Re: Kerr McGee Cushing  
Release of Unaffected Areas

SUBJECT: ISSUANCE OF SPECIAL NUCLEAR MATERIALS LICENSE NO. SNM-1999 TO  
KERR-MCGEE CORPORATION TO POSSESS CONTAMINATED MATERIAL AT THE  
CUSHING SITE

DOCKET NO: 70-3073  
LICENSE NO: SNM-1999  
LICENSEE: KERR-McGEE CORPORATION  
SUBJECT: SAFETY EVALUATION REPORT, LICENSE APPLICATION DATED  
OCTOBER 17, 1991, AS REVISED ON SEPTEMBER 25, 1992, AND  
SUPPLEMENTED ON DECEMBER 18, 1992, JANUARY 14, 1993, AND  
FEBRUARY 23, 1993  
RE: POSSESSION OF URANIUM AND THORIUM AT THE  
CUSHING REFINERY SITE

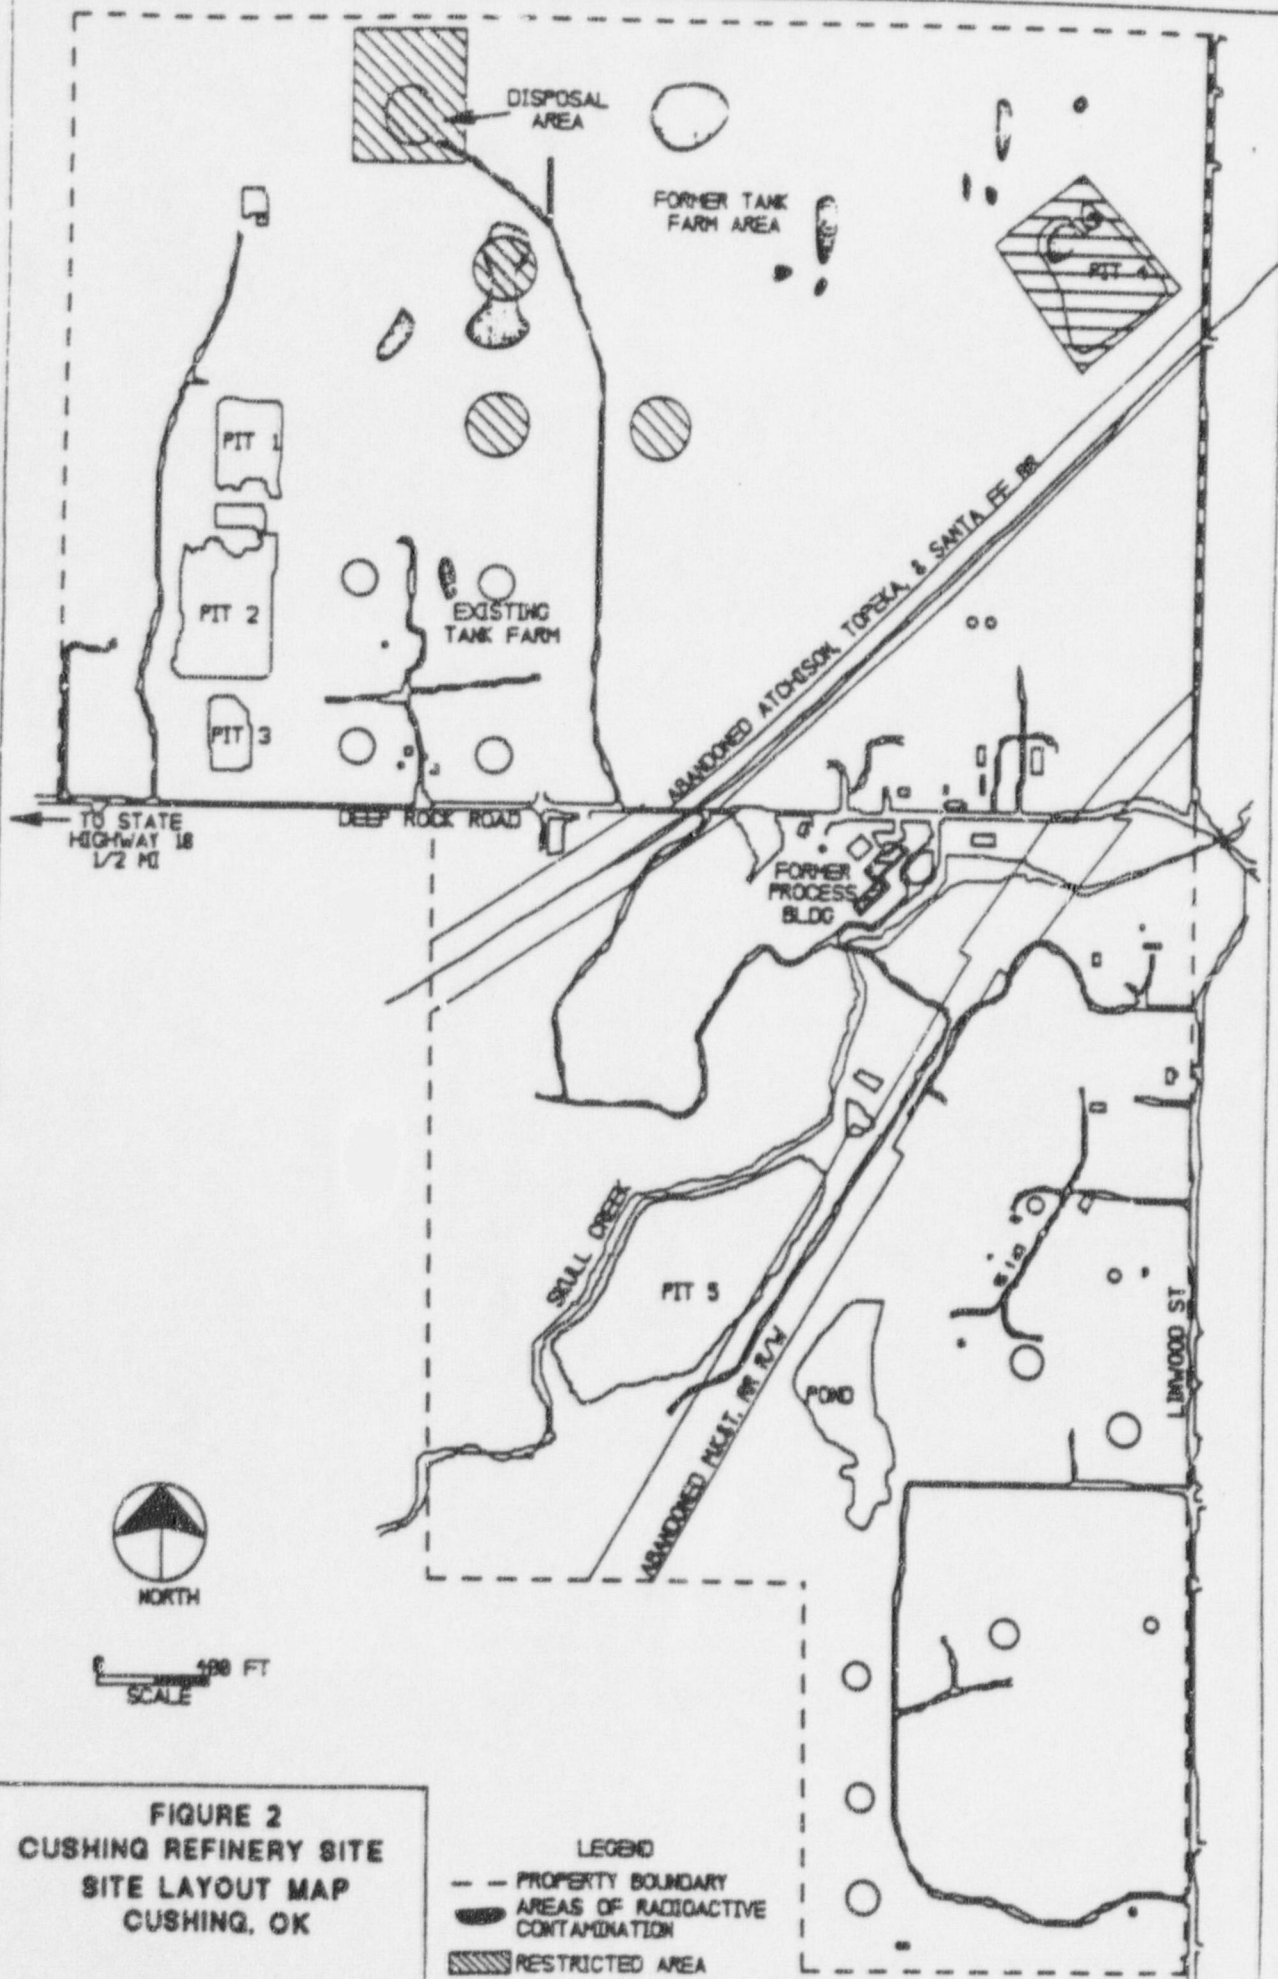
Three former petroleum storage tank pads, located north of Deep Rock Road on the Cushing Site, will be used to temporarily stockpile the excavated contaminated material not shipped to a disposal facility. The tank pads will be upgraded by constructing a three-foot-high berm around each pad. Also, a fence will be

constructed around each storage area to restrict access. During sorting and stockpiling operations, wind dispersal of the contaminated soils placed in the storage areas will be controlled by either wetting or plastic sheeting. After sorting and stockpiling has been completed, vegetative covers will be established over the temporary storage areas to control wind dispersion until the final disposition of the material is decided.

The application does not include a description of the potential for flooding of and erosion from the temporary storage areas, which could lead to the release of contaminated water, and the methods to be employed to minimize flooding and erosion. Therefore, the staff recommend the following license condition:

These areas are shown on Figure 2 as "radiation areas." *radiation areas*

**CONDITION 3** Prior to transferring contaminated material to any of the three temporary storage areas, Kerr-McGee shall submit, by license amendment request, an analysis of the ability of the three temporary storage areas to effectively resist erosion by wind and water.
